Comment #70

Comment 70, proposed remedy

Figure 68-8—Measurement configuration for normative comprehensive stressed receiver sensitivity test

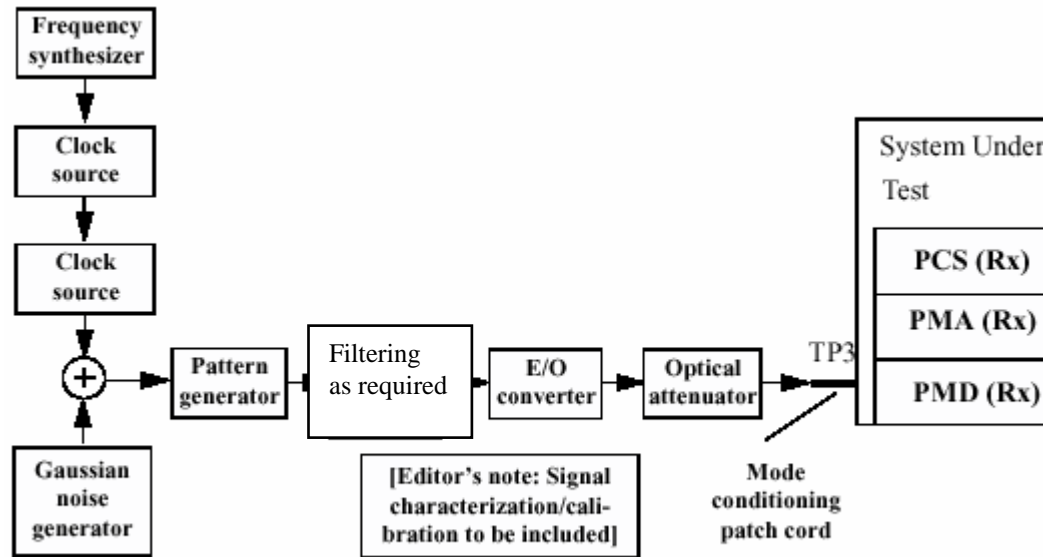
Comment 70, cont'd

- Change filtering block, as shown
- Remove editor's note
